02-2017 LATEST REVISION DATE	 APPROVED BY BRIDGE ENGINEER	 STANDARD DESIGN - 40' ROADWAY, 3 SPAN BRIDGES ROLLED STEEL BEAM BRIDGES OCTOBER, 2014

SKEWED FRAMING PLAN
(R.A. SHOWN, L.A. SIMILAR)

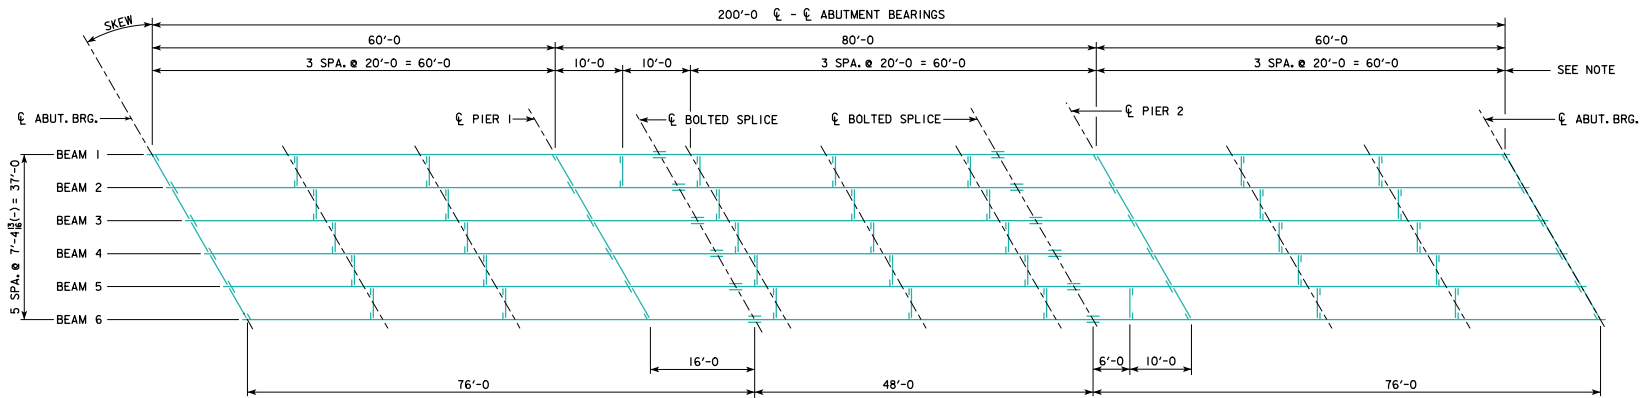
REVISED 02-2017 - CHANGED DIAPHRAGM SPACING IN SKEWED FRAMING PLAN (WAS 4 SPACED AT 20'-0" IN 80'-0" CENTER SPAN, ADDED DIAPHRAGMS TO SKEWED FRAMING PLAN IN OUTER BAYS, BETWEEN BEAMS 1 & 2 AND 5 & 6 OF 80'-0" CENTER SPAN, 10'-0" FROM PIER CENTERLINES.
